To all users of the SIEMENS MAMMOMAT
Inspiration – Biopsy Unit

Subject: Customer Information - MAMMOMAT Inspiration Biopsy Unit

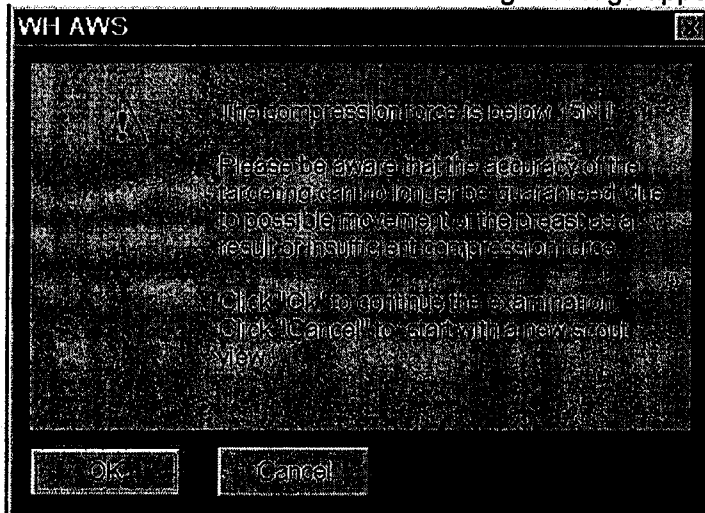
As a measure the software operating the procedure of stereotactic biopsy is modified. If the compression force decreases below 15N the following message appears on AWS:

It is up to the user to accept possible inaccuracy of targeting and continue the biopsy examination with clicking "Ok" or not accepting possible inaccuracy and start with a new scout view with clicking "Cancel".
